18-073ARB-MPR – VESSELS' RESIDENCE

Proposal

Construction of a new second-story addition over an existing single-story addition, a new single-story mudroom, and a new attached 1½-story, 3-garage and recroom.

ART Recommendations

c. Attached 3-Car Garage & Driveway

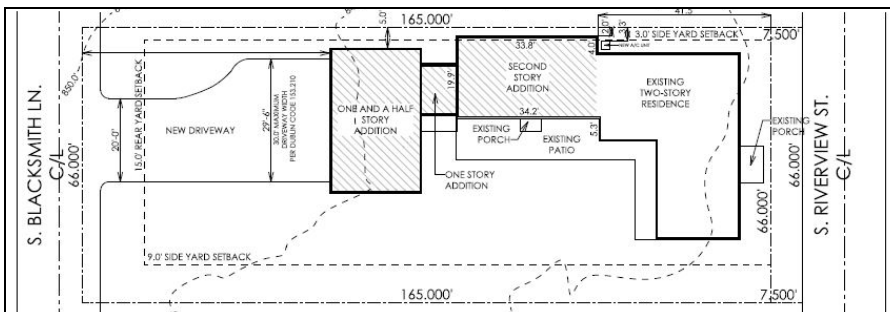
The applicant is proposing an attached 1½-story, three-car garage with a finished space above the garage including a recreation room, bathroom, and kitchenette. The proposed attached garage has a gabled roof on both the west and east elevations. The exterior of the garage is proposed to be white, vertical board and batten siding (HardiePanel Cedarmill) to match the modifications on the principle structure, with all three of the garage doors to be C.H.I. Stamped Carriage Long Overhead Doors. A proposed stone watertable is incorporated to complement the proposed exterior modifications to the previous additions.

The applicant has worked with Staff to reduce the number of rooflines of the proposed garage addition; however, Staff's foremost concern is the overall height of the garage being 9 inches shorter than the historic structure, and 5 inches taller than the proposed addition. It is customary for structures to stepdown as the structure moves toward an alley, and not to compete with the historically significant structure.

Staff and ART have concerns the proposed mass, scale, and total height of the attached garage overpowering both the original historic structure and surrounding properties. ART recommends the applicant with the Architectural Review Board on the design of the proposed garage to meet the program needs of the owner, while maintaining the desire character of the District.
